FOR PERCOLATION TESTING AND SITE EVALUATION

RE: Percolation Test Report; Tax Map 23, Parcel 74, Parcel 2 (beyond end of Manor Lane)

RE: Manor Lane (Tax Map 23, Parcel 74) Percolation Certification Plan

RE: Comment on Percolation Test Plan for "Manor Lane"

Manor Lane
Per Test Plan

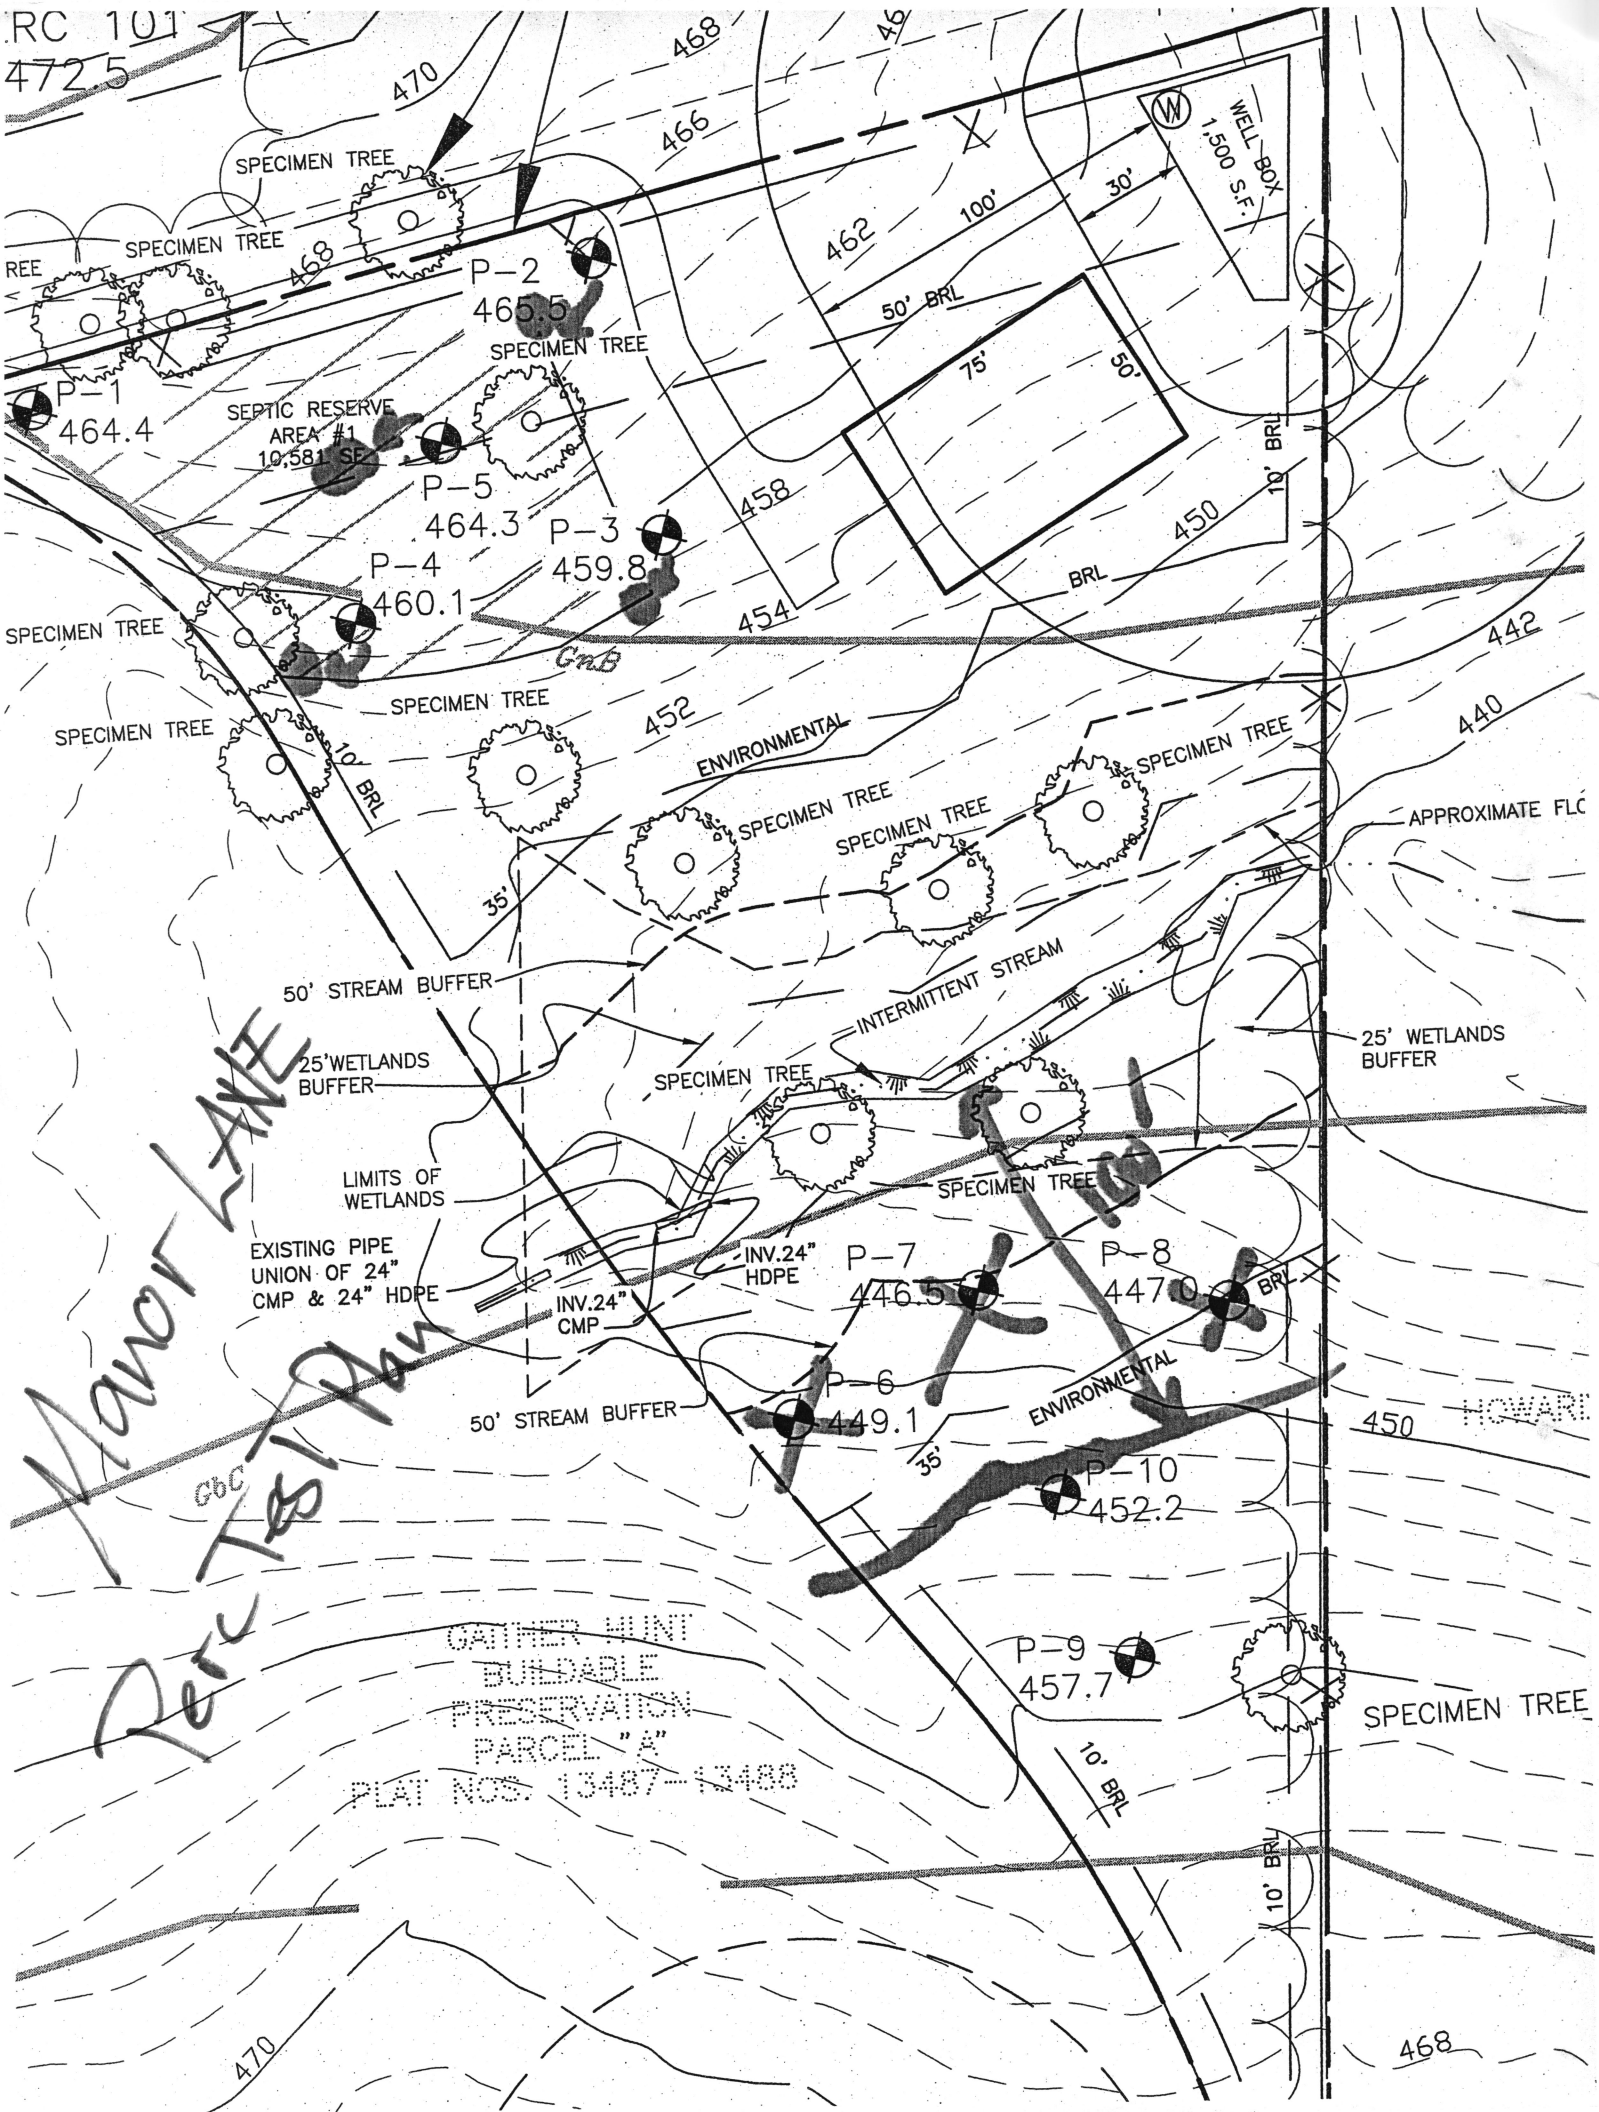
See attached PDF, a mark-up of the submitted (1/8/2016) Perc Test Plan for "Manor Lane".

Adjust 4 of the proposed perc test locations as indicated. Locations indicated on the plan as "P-6", "P-7", and "P-8" will not be tested as that area is within 100 feet of an intermittent stream.

Wet-season testing is required.

SOA $\frac{1}{2}$
not 100' from

Stream,
"ephemeral ditch"?

G15 shows a stream
